Access Compliance Report

Public Rights-of-Way

Intersection ID: 47611	Main Street: WYALONG_DR	Cross Street: MINTWORTH_AV	Location: NE
ADA ID: 69FAA85AD425	Ramp Type: Perp	Initial Pass/Fail: Fail	Overall Compliance: No
		Severity Score: 12.5

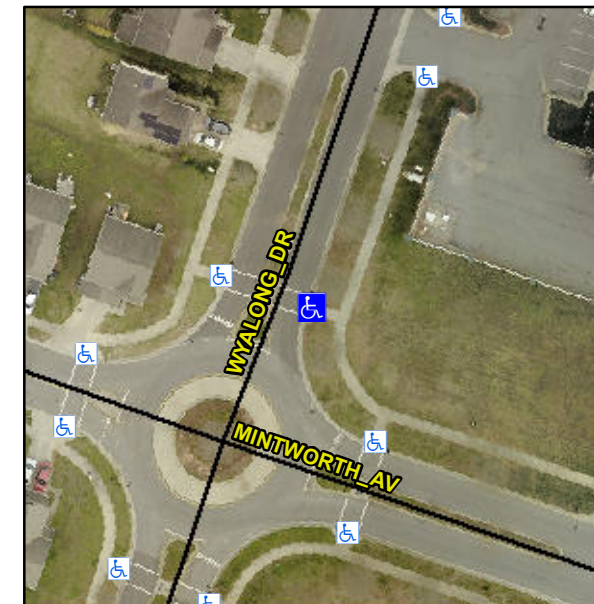
Compliance	Description	Data	Compliance	Description	Data
N/A	Ramp Length (in)	180.0	No	Ramp Slope (%)	8.7
Yes	Ramp Width (in)	74.0	Yes	Ramp XSlope (%)	0.9
N/A	Flare Type LT	N/A	N/A	Flare Type RT	N/A
N/A	Flare Slope LT (%)	N/A	N/A	Flare Slope RT (%)	N/A
N/A	Flare Traversable LT?	N/A	N/A	Flare Traversable RT?	N/A
N/A	Landing Length (in)	N/A	N/A	DWS Provided?	N/A
N/A	Landing Width (in)	N/A	N/A	DWS Contrast?	N/A
N/A	Landing Slope (%)	N/A	N/A	DWS Length (in)	N/A
N/A	Landing X Slope (%)	N/A	N/A	DWS Full Width?	N/A
N/A	Landing Curb? (Y/N)	N/A	N/A	DWS Offset (in)	N/A
N/A	Shared Landing?	N/A			
N/A	Gutter Ponding?	N/A	N/A	Gutter Slope (%)	N/A
N/A	Gutter Lip Ht (in)	N/A	N/A	Gutter X Slope (%)	N/A
N/A	Painted X Walk1?	Yes	N/A	Painted X Walk2?	N/A
	X Walk 1 Direction	To NW		X Walk 2 Direction	N/A
N/A	X Walk 1 Width (in)	119.0	N/A	X Walk 2 Width (in)	N/A
	X Walk 1 Slope (%)	5.8		X Walk 2 Slope (%)	N/A
	X Walk 1 X Slope (%)	1.0		X Walk 2 X Slope (%)	N/A

Remove & Replace Entire Ramp.

R304.2.2
